June 13, 2014

BTB 51769 (1406)

## Safety Recall: ILX Headlights

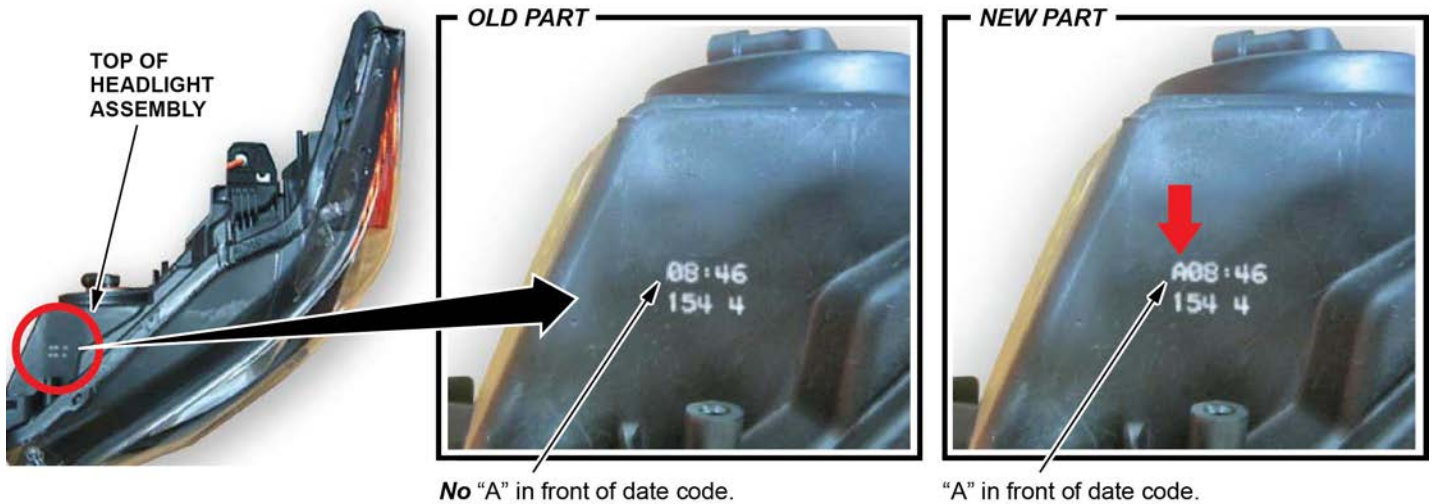
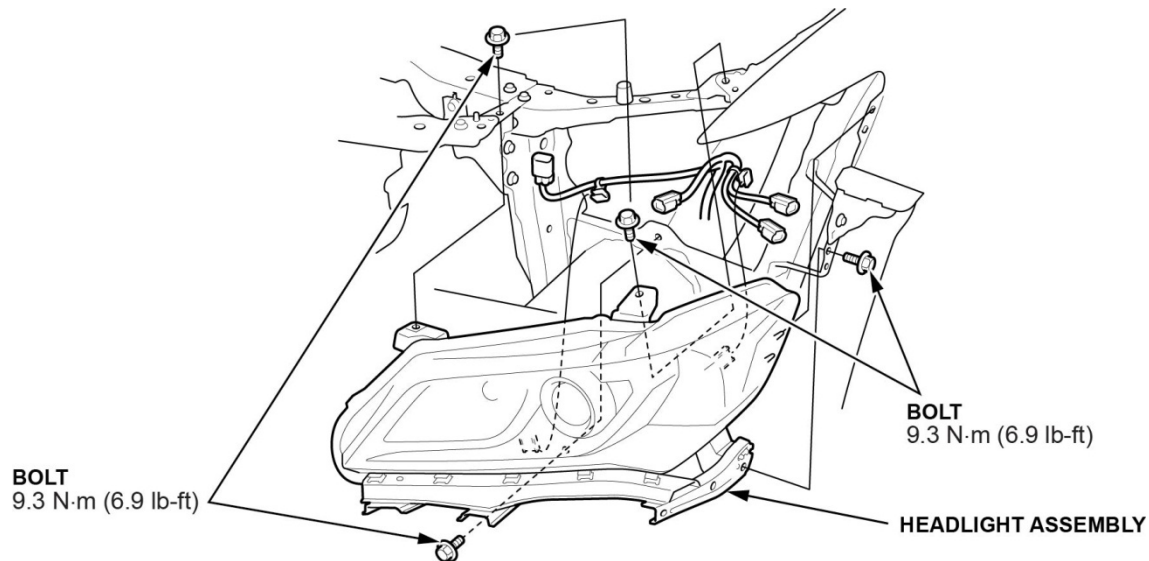
NOTE: Just in case the headlight assemblies get mixed up on your work bench, the improved head light assemblies

have the letter (A) in front of the date code.
